Product Update Bulletin

Bulletin 16-0008 Effective Date: 11/8/16

PRODUCTS: Model 2102-0-01 Ford Transit Mounting Channel Kit

Transit Roof Rack Mounting Guidelines

Figure 1: Typical roof rack attachment points

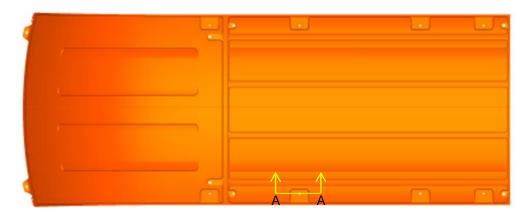
It is recommended that all lateral roof rack beams should be centered over the roof mounting points / depressions. The number of roof rack attachment points varies by model from 6 to 10 positions. Roof racks should be designed to equally distribute all added cargo loads.

Figure 2: Section A-A from Fig. 1

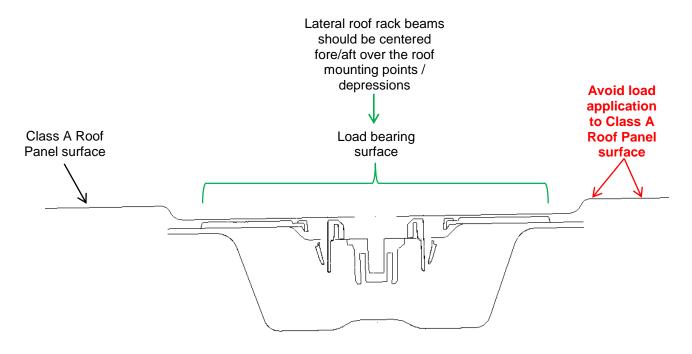
In order to prevent damage to the roof surface panel, the roof load (rack/ cargo) needs to be distributed to the proper load bearing surface, i.e. the roof rack or attachment footprint should not contact the class A surface of the roof panel (see Section A in Figure 2). The use of a spacer at each attachment point is recommended for constructions that may require additional clearance to avoid point loading Class A surface of the roof panel (See Figure 3). Roof rack design should consider use all of all available roof attachments.
